Service Bulletin

Bulletin No.: 16-NA-350

Subject: Buzz or Rattle Noise from Door Trim Panel

| Brand: Model: | | Model Year: | | VIN: | | Engine: | Transmission: |
|---------------|---------|-------------|------|------|----|---------|---------------|
| Chevrolet | Camaro | 2016 | 2017 | | | All | All |

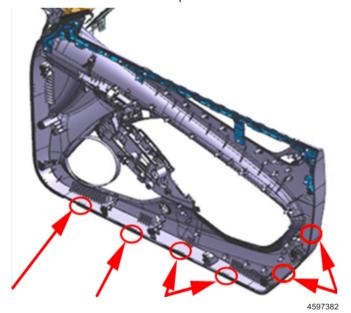
| Involved Region or Country | North America, Korea, Europe and all N.A. Export Regions | | |
|----------------------------|--|--|--|
| Condition | Some customers may comment on a buzz or rattle type noise coming from the door trim panel. | | |
| Cause | This may be due to speaker vibration caused by high bass. | | |

- 2. Once the door trim panel is removed, install flocking tape in the 6 locations along the door panel edge as shown above.
- 3. Reinstall the door trim panel and verify the concern is corrected.
